# UNITED STATES PATENT AND TRADEMARK OFFICE

APPLICATION NO.	FILING DATE	FIRST NAMED INVENTOR	ATTORNEY DOCKET NO.	CONFIRMATION NO.
10/767,094	01/29/2004	Robert F, Debrody	202500-767	4601
7	590 08/09/2005		EXAM	INER
William Squire, Esq.			LUGO, CARLOS	
c/o Carella, Byrne, Bain, Gilfillan, Cecchi, Stewart & Olstein			ART UNIT	PAPER NUMBER
5 Becker Farm Road			3676	
Roseland, NJ 07068			DATE MAILED: 08/09/2005

### **DETAILED ACTION**

Alfachment #1

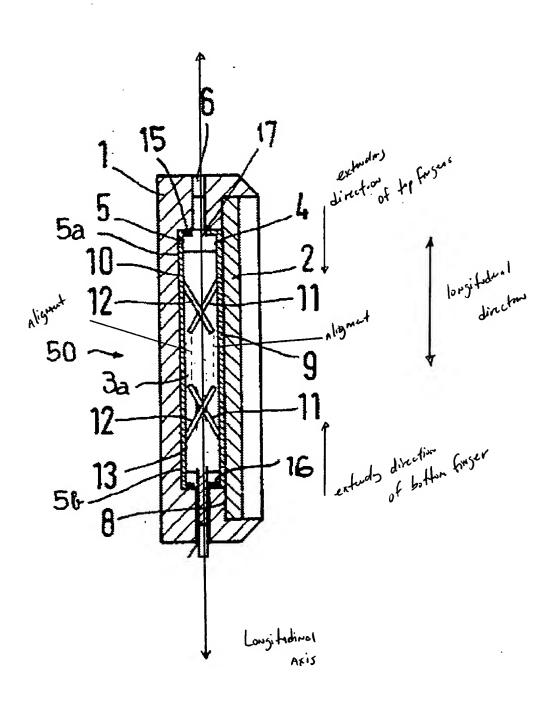
Regarding claims 1 and 29-34, Spirig discloses a bi-directional locking device (1) including a locking arrangement (4) for receiving and locking a shackle (3) thereto.

The shackle has at least one locking element (13 and 14). The shackle is insertable into a device chamber for engaging with the locking arrangement.

The locking arrangement comprises a body defining the chamber therein and has a longitudinal axis defining a longitudinal direction. The body has opposing top and bottom ends. The top end defines a top opening communicating with the chamber in the longitudinal direction, and the bottom end defines a bottom opening communicating with the chamber in the longitudinal direction.

A plurality of resilient fingers (11 and 12) is positioned in the chamber. Respective ones fingers extends in opposing directions toward and substantially aligned with each other in the longitudinal direction. The plurality of fingers each is positioned to allow passage of the at least one locking element of the shackle in first

and second opposite insertion longitudinal directions through either the top or the bottom opening (with respect to the location where the shackle is lock). At least one of the fingers is used for locking engaging at least one locking element to preclude the shackle withdrawal from the chamber in a direction opposite to the insertion direction to lock the shackle to the body in the opposite direction (see attachment #1).
